Comments on 10GBASE-T Draft 3.1

**IEEE P802.3an Task Force
Denver, March 7 - 9, 2006**

Gottfried Ungerboeck

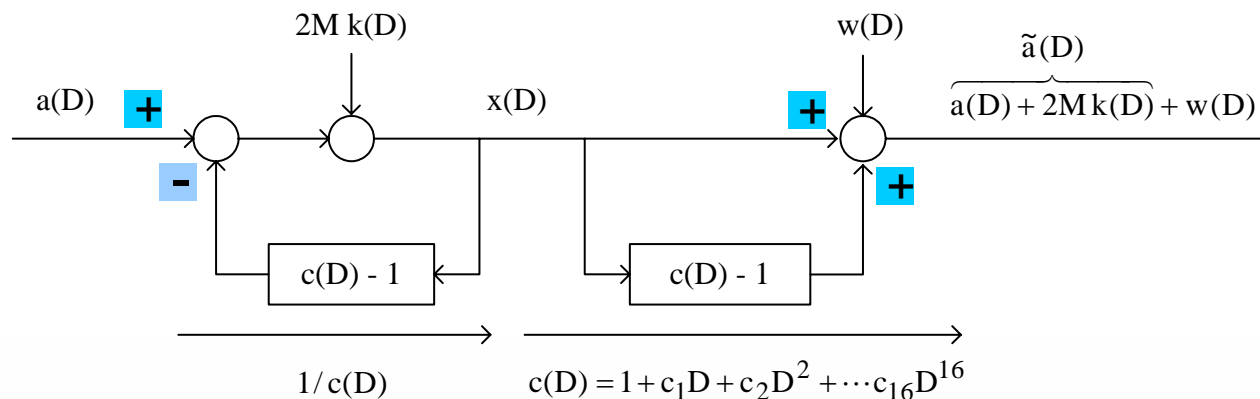
Motion 1: Adopt inclusion of state-indicator bits in message field.

Motion 2: Let other message field bits be:

- (a) LRS conveying `loc_rcvr_status` to remote PHY
- (b) EST ... `en_slave_tx` (PMA_Training_M), or
PED ... `PBO_exch_done` (PMA_PBO_exch), or
CED ... `coeff_exch_done` (PMA_Coff_exch).

Motion 3: Eliminate `trans_to_Coeff_Exch`, `trans_to_Fine_Adjust`, and `trans_to_PCS_Test`.

State indicator bits SD1,0 and transition count TC are sufficient to signal state transitions.
